Agreement No. LW 02/2012
Environmental Team Services for Contract No. CV/2012/02
Construction of Sewage Pumping Station near Tsz Tin Road and Associated Sewerage Works in Area 54, Tuen Mun

Proposed Air Quality and Noise Monitoring Stations (Revised)
(Environmental Permit No.: EP-381/2009)

Proposed Monitoring Station for Air Quality and Noise

Figure 1 - Proposed Alternative Location for Air and Noise Monitoring Stations

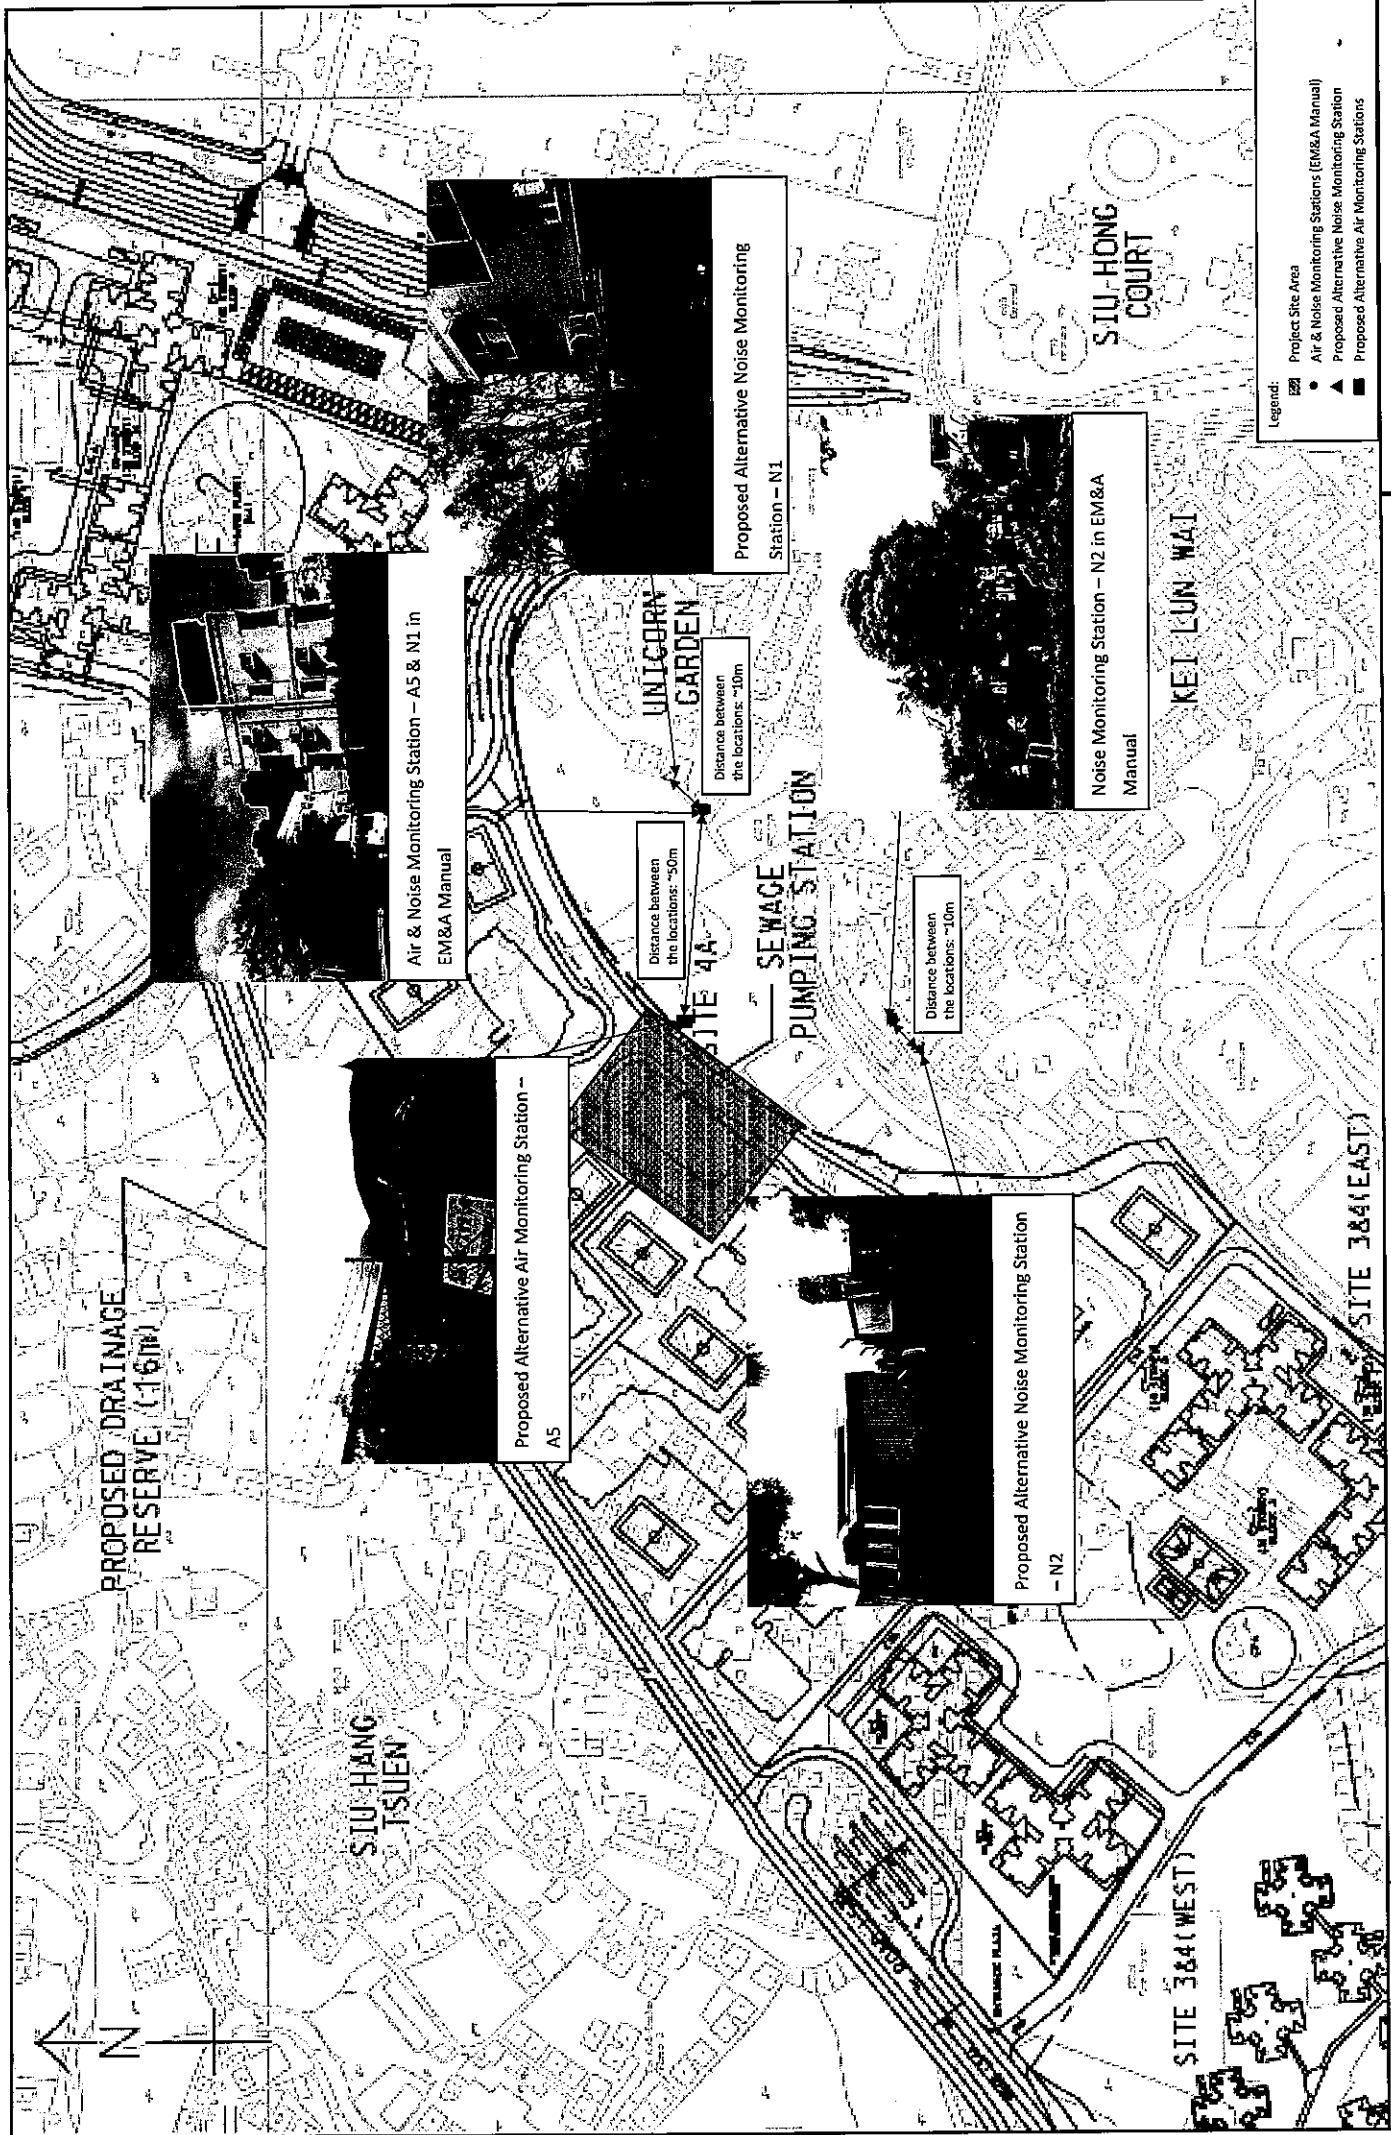
Referring to your revised proposal received on 17 December 2012, please note we have no objection to your proposed alternative locations of air quality and noise monitoring stations.

The ET should ensure that the setup of monitoring equipment follows the specifications as described in Sections 2.33 and 3.9 of the approved EM&A Manual.

I have no objection to the proposed alternative locations of air quality monitoring station A5 and noise monitoring stations N1 and N2 as given in the proposal covered by your above quoted letter.

Please seek EPD's approval on the proposed alternative locations promptly.
